ADDENDUM NO. 1

May 6, 2022

LIBERTY INTERMEDIATE SCHOOL ADDITIONS AND RENOVATIONS
Chesterton, IN 46304

This Addendum consists of Pages ADD 1-1 through ADD 1-3 and attached Addendum No. 1 from Gibraltar Design dated May 5, 2022 and consisting of 7 pages, Specification Section 07 53 25 - Single-Ply Roofing Rehabilitation, and 99 drawings.

SHEET
A
P-201

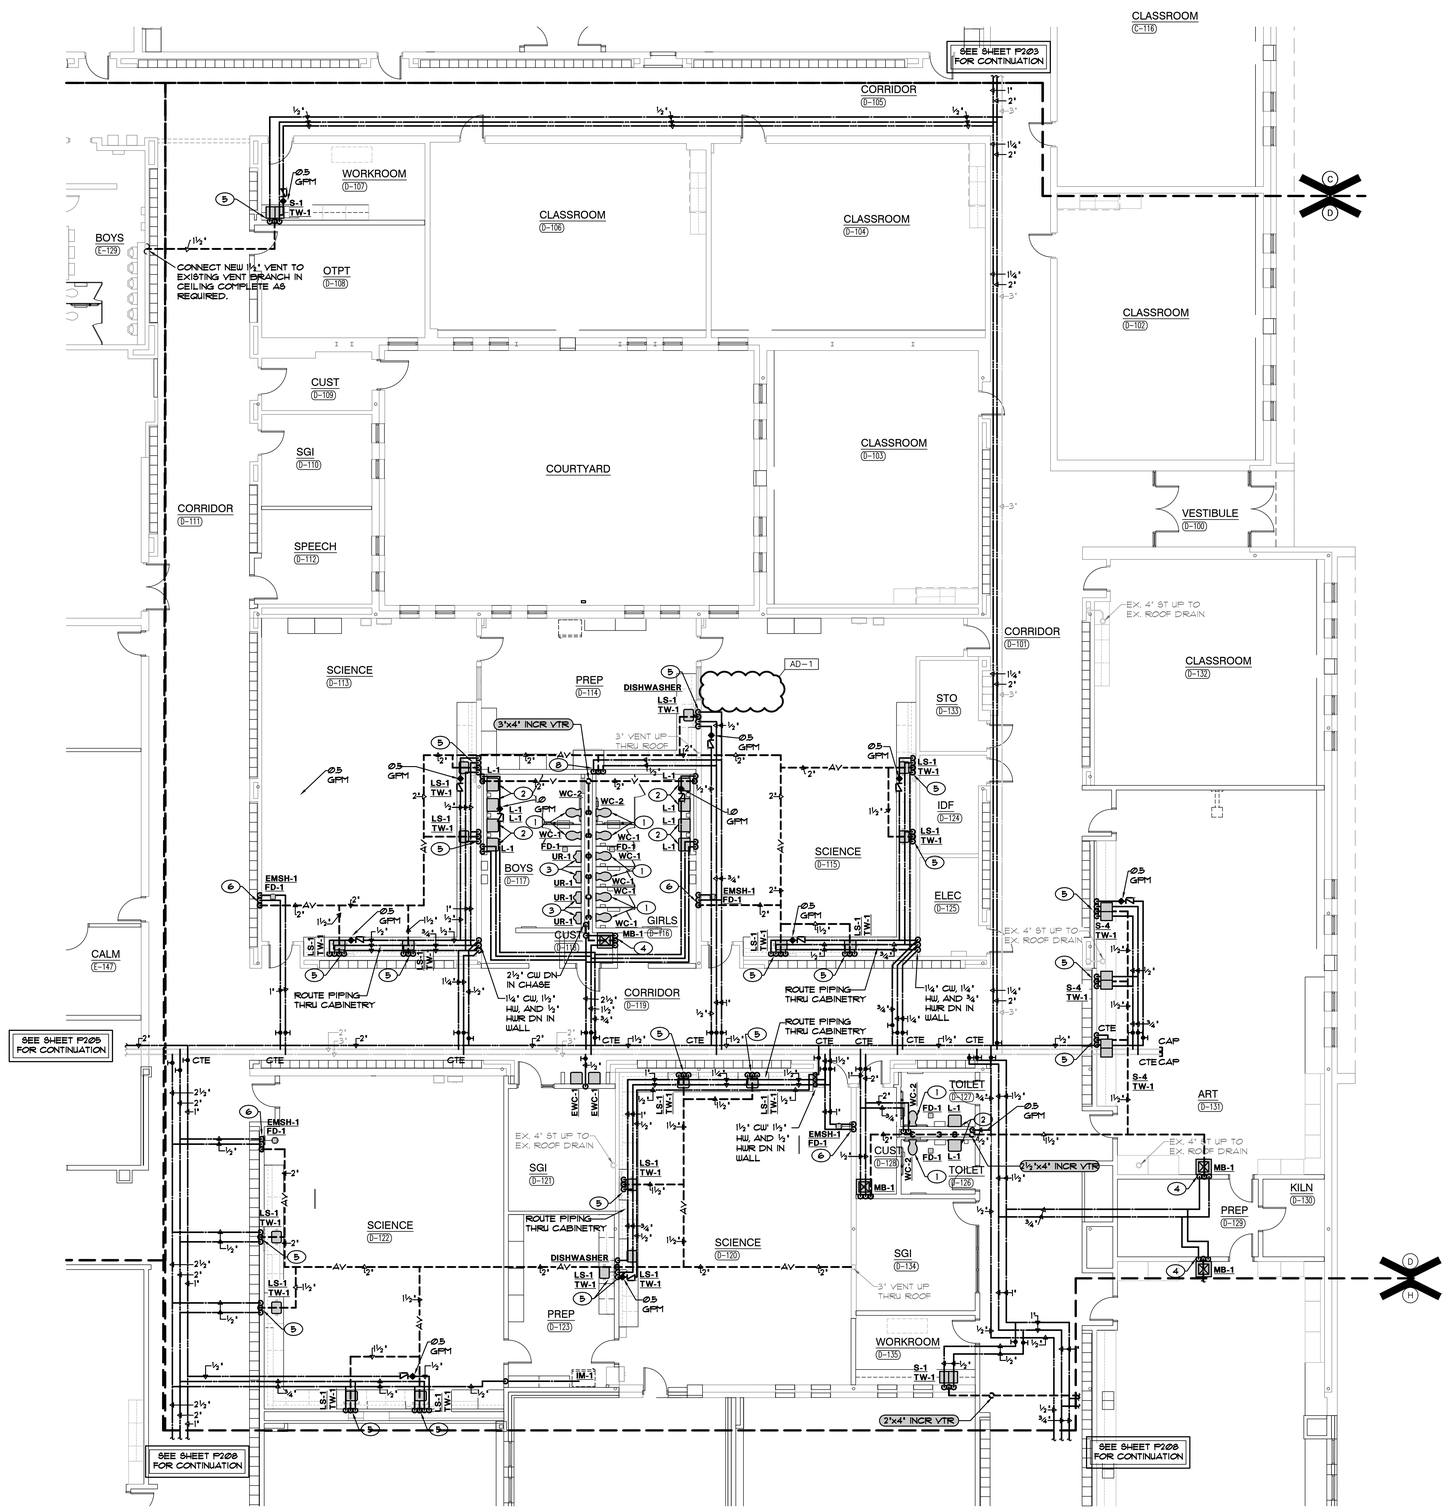
33. Sheet P-201

A. Refer to revised full-size drawing, included in this Addendum, for L-1 and FD-1 added for Concessions A-126.

SHEET
D
P-204

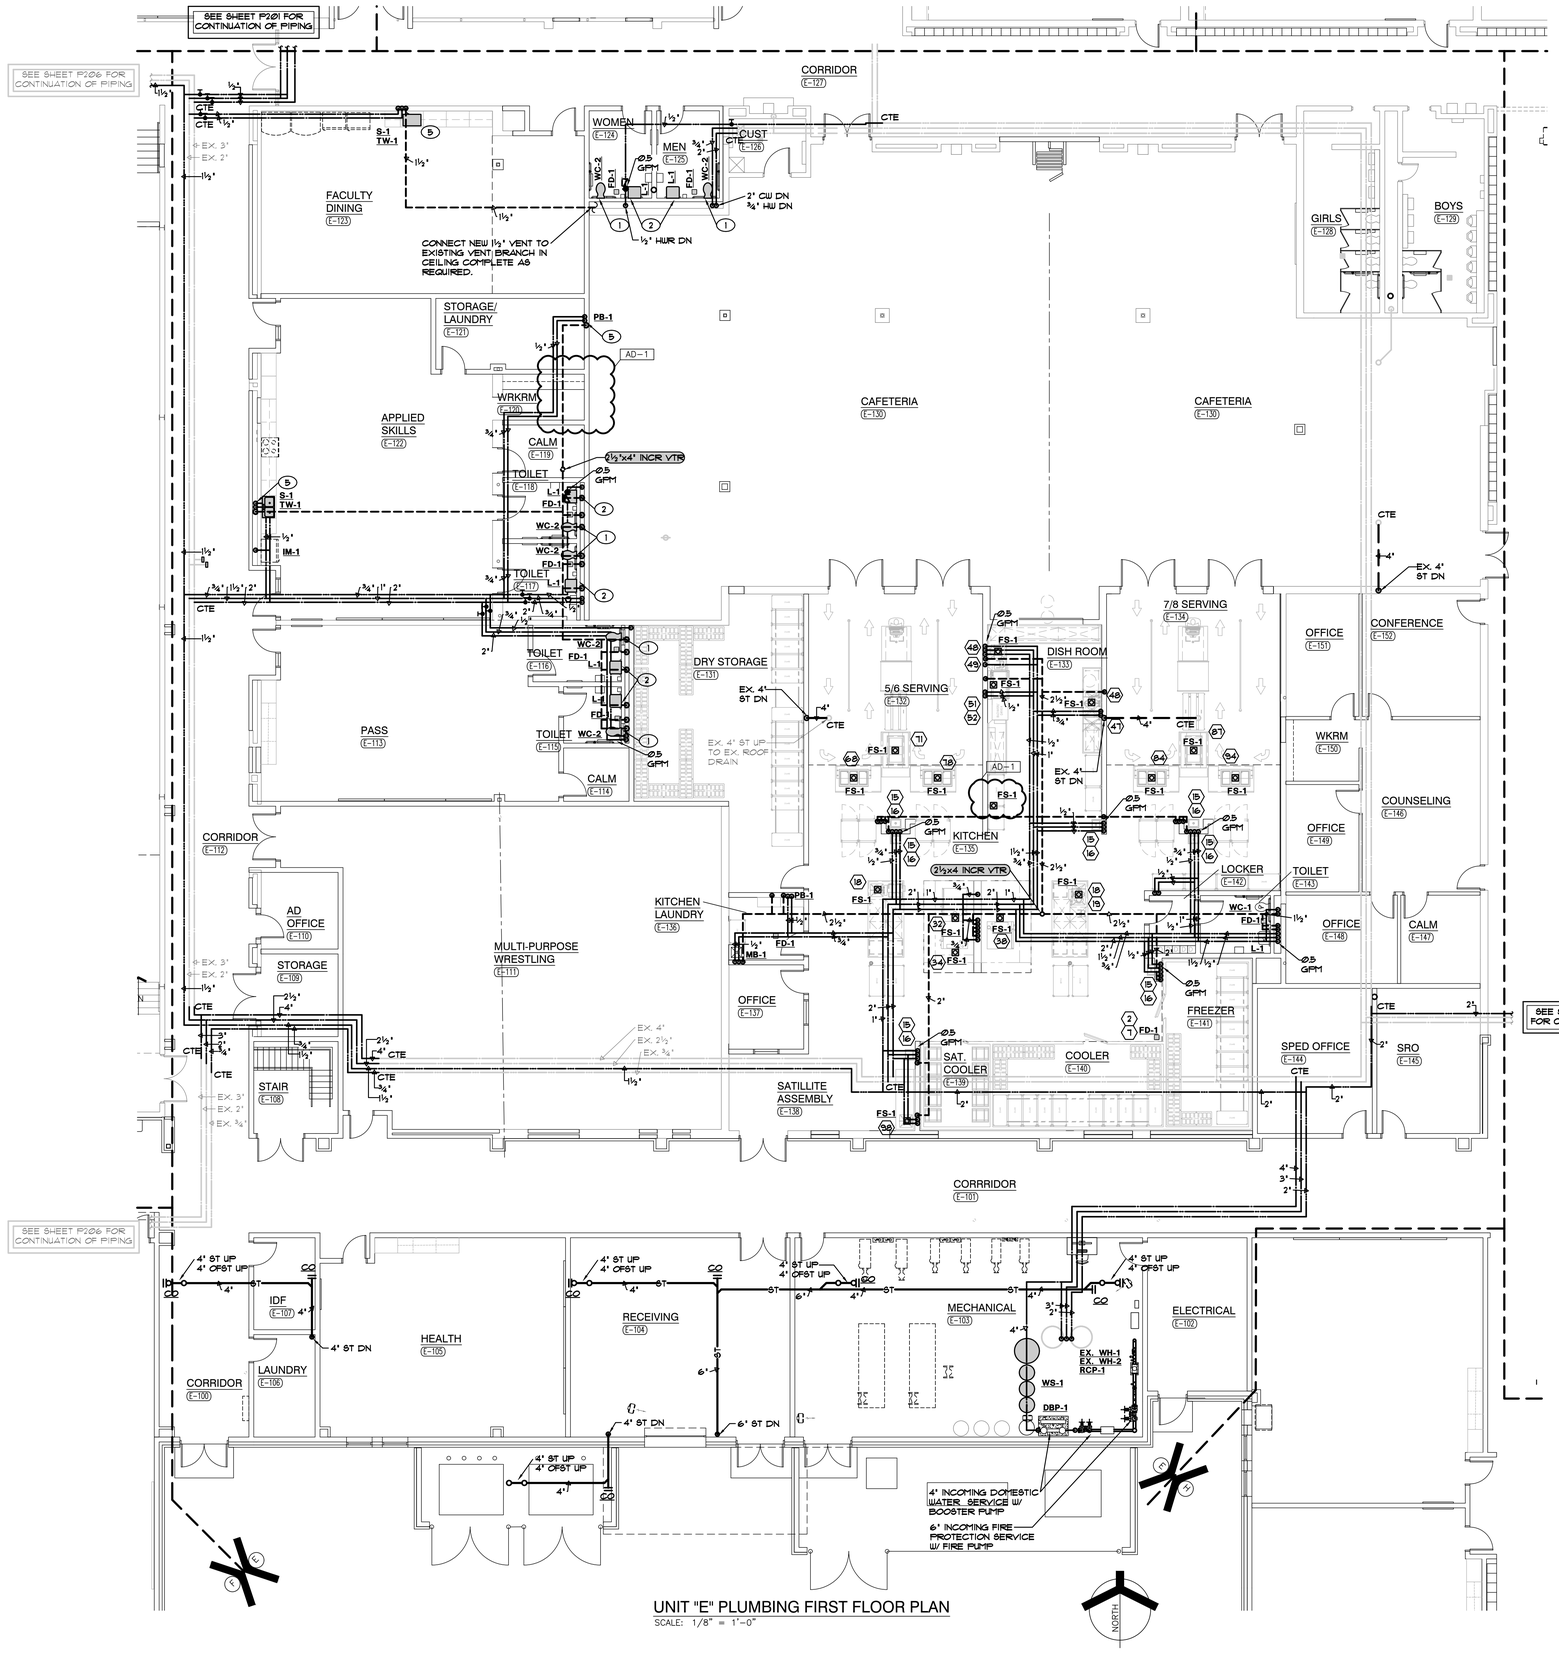
34. Sheet P-204

A. Refer to revised full-size drawing, included in this Addendum, for dishwasher note removed.

SHEET
E P-205

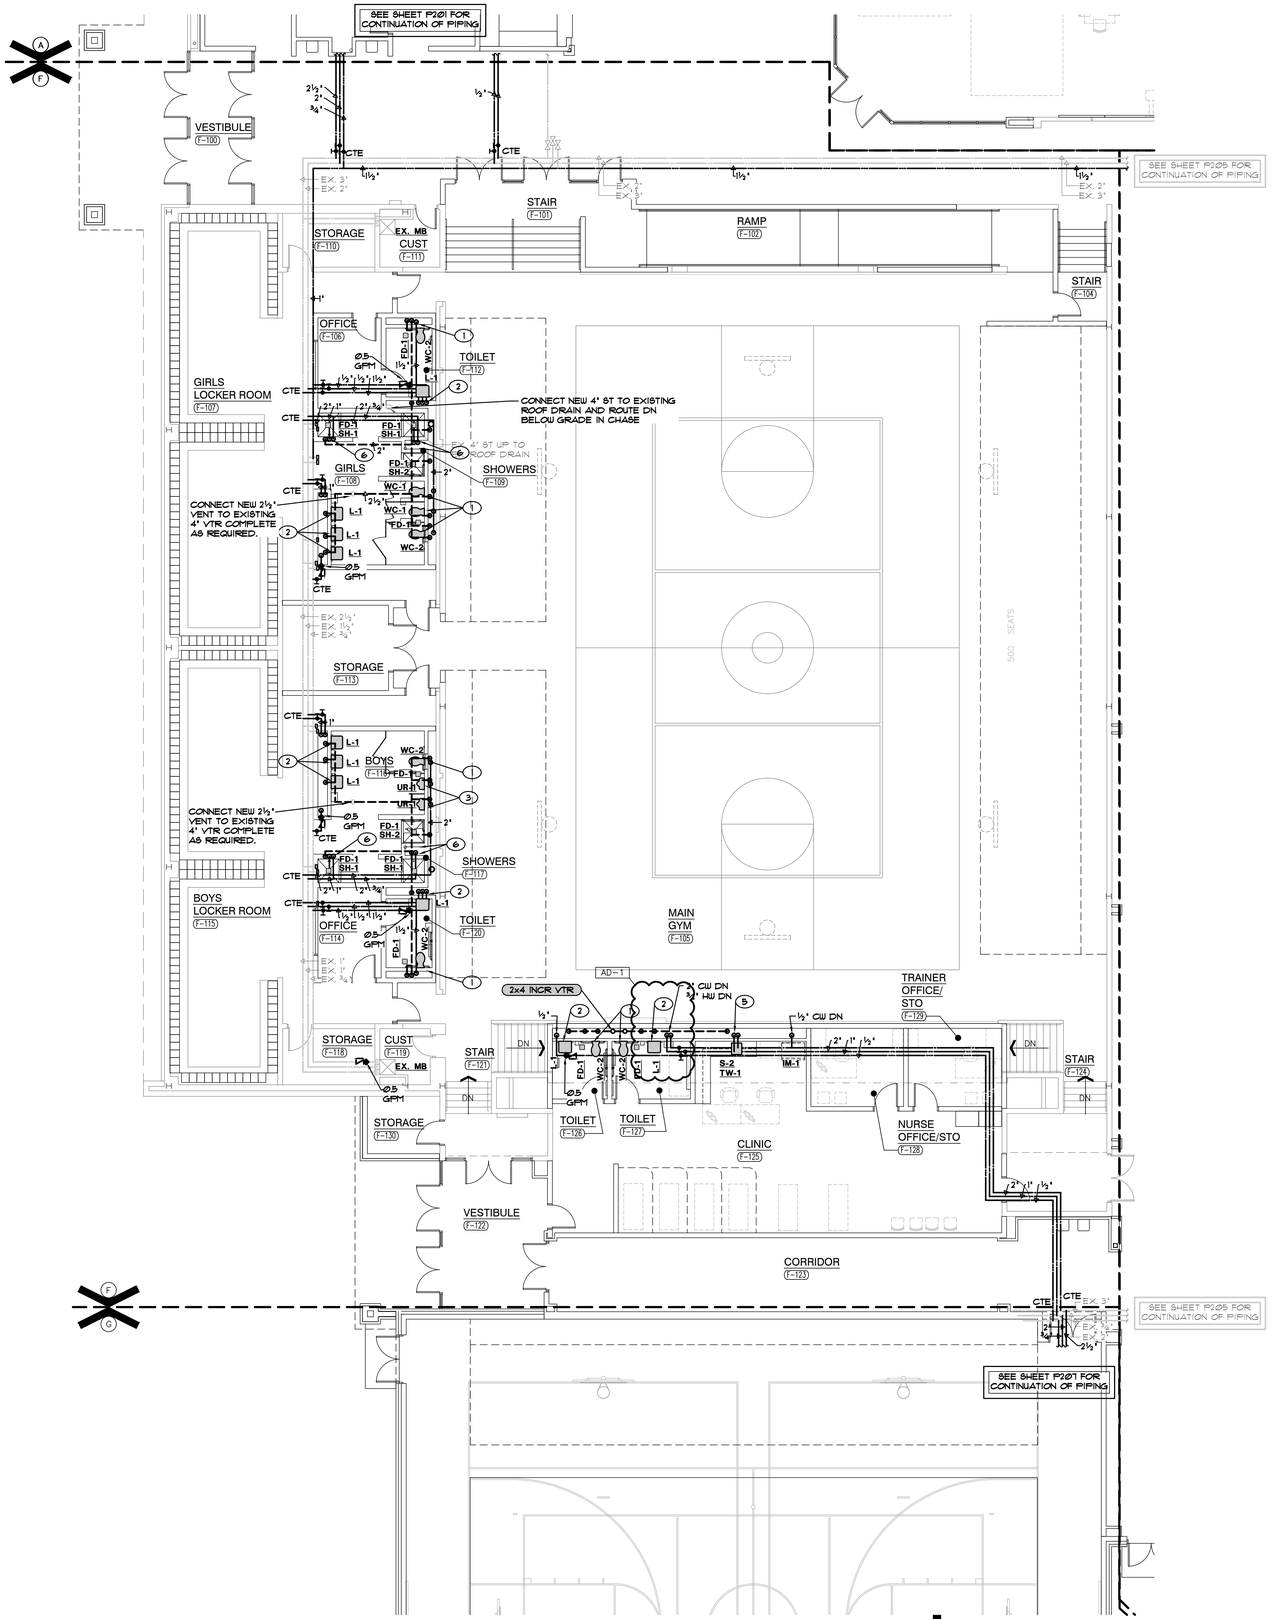
35. Sheet P-205

A. Refer to revised full-size drawing, included in this Addendum, for the following revisions.

1. Added a FS-1.
2. Removed S-1.

SHEET
E-001

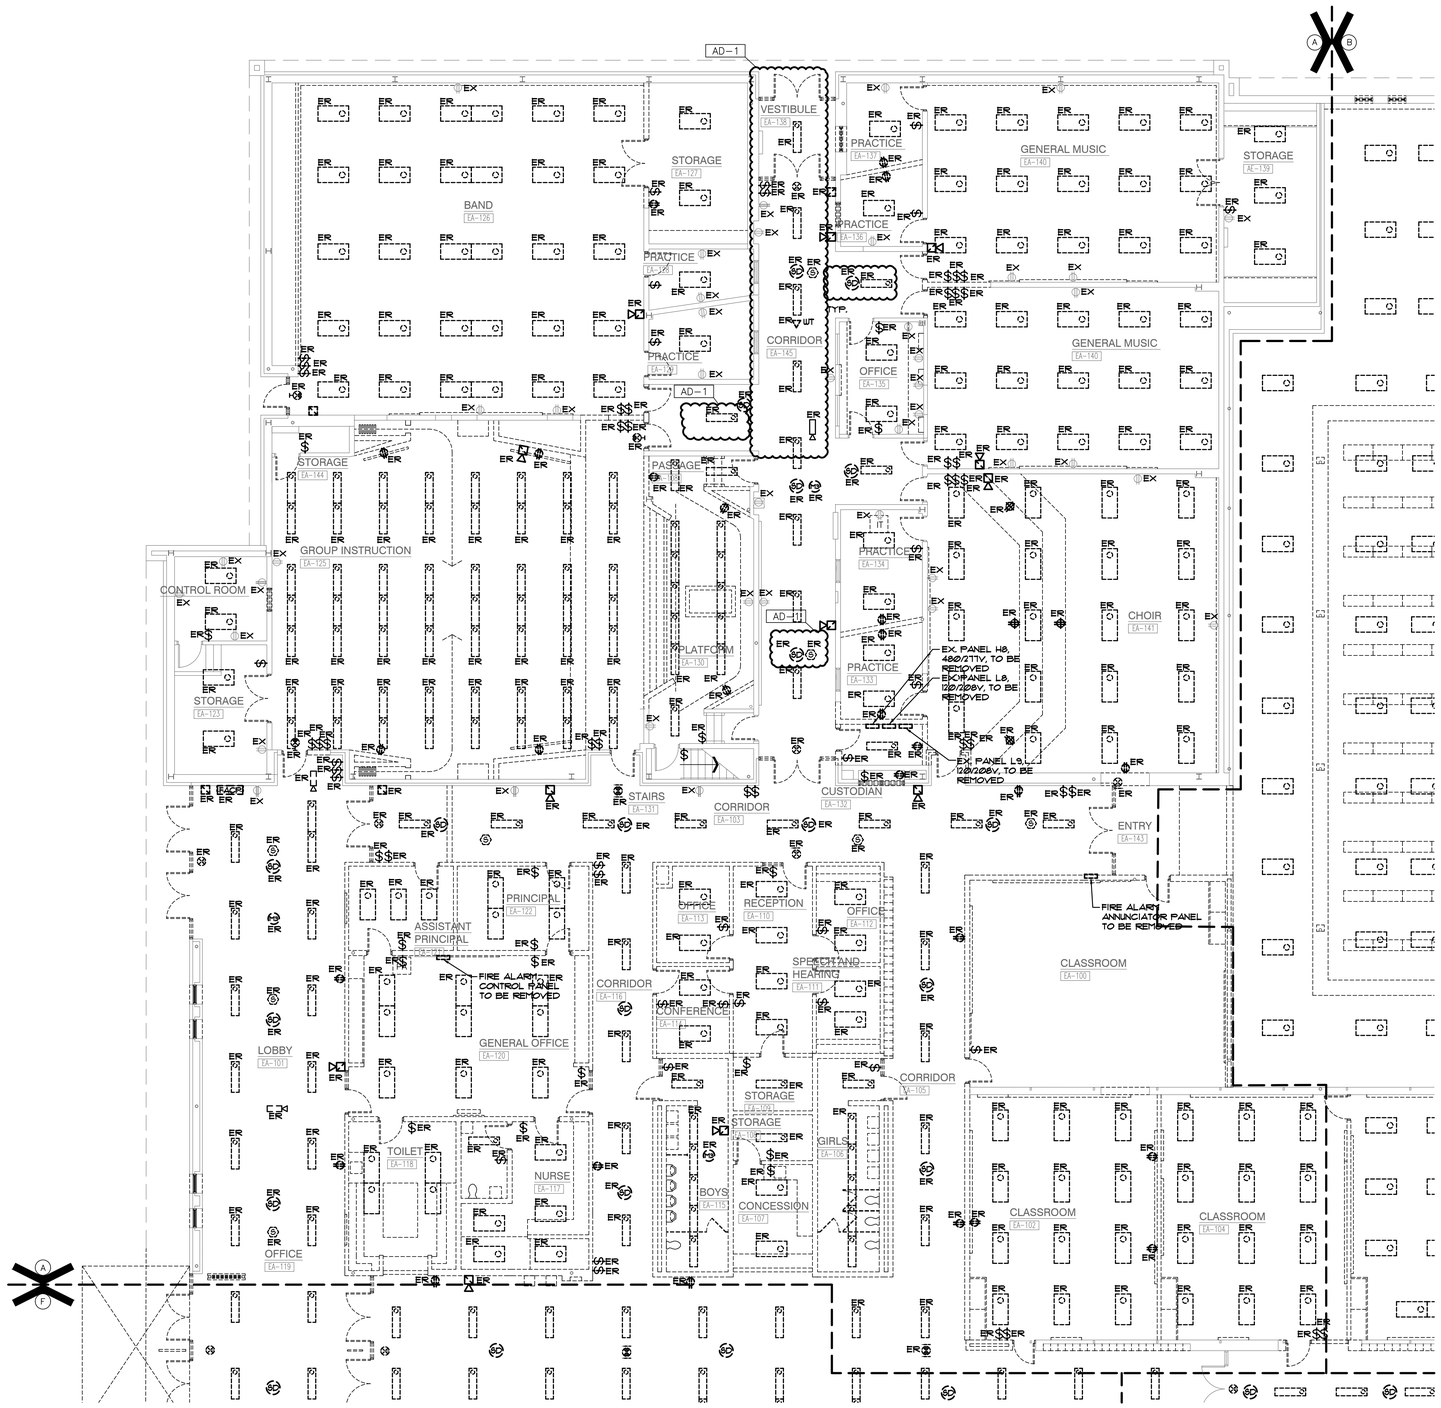
39. Sheet E-001

A. Refer to revised full-size drawing, included in this Addendum, for revised symbol list and new symbols added.

SHEET
F
EL106

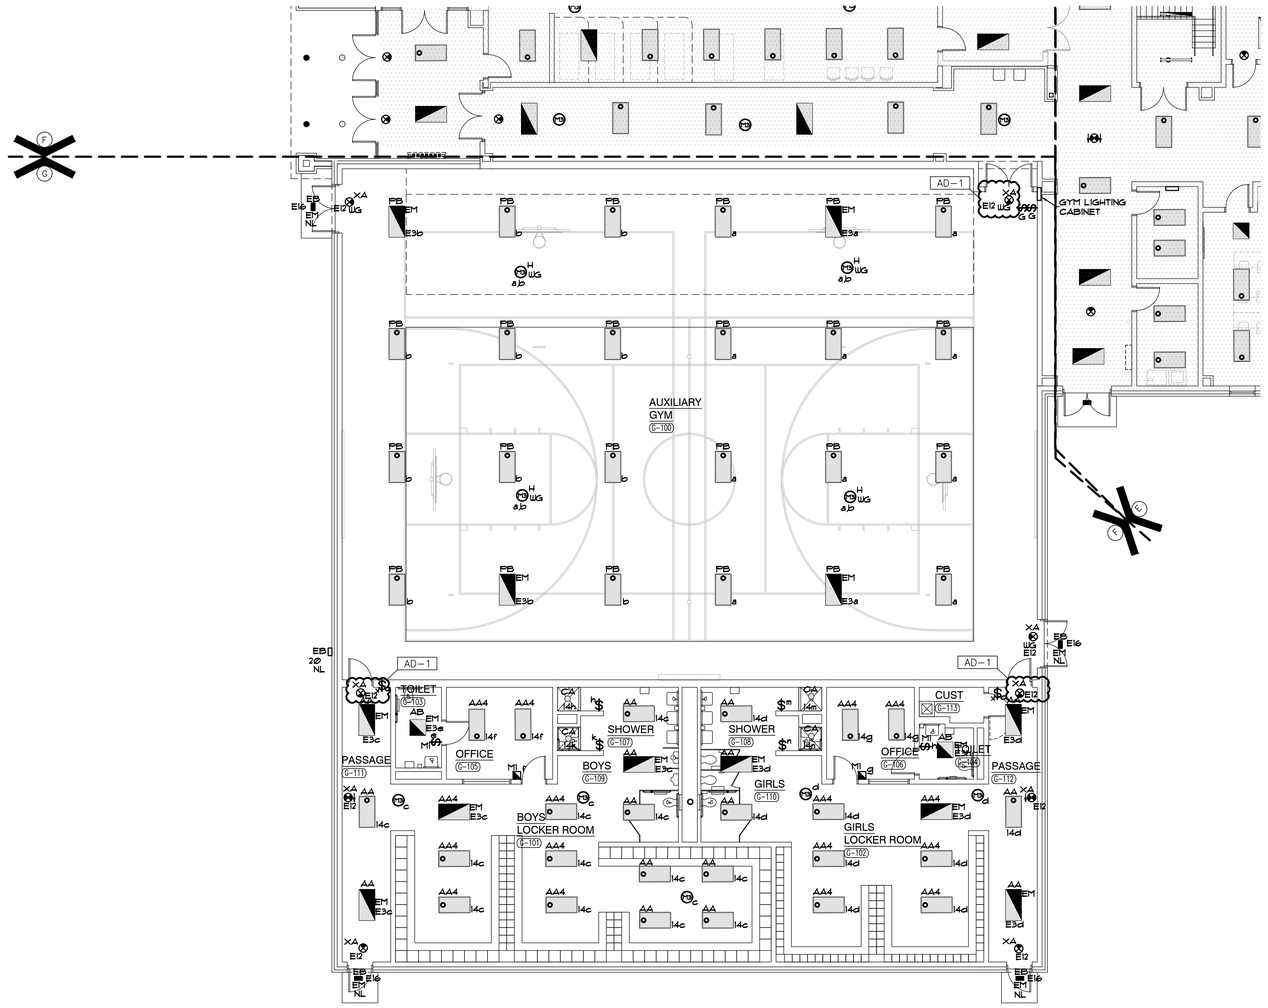
46. Sheet EL106

A. Refer to revised full-size drawing, included in this Addendum, for revised exit signs in stairway and locker room.
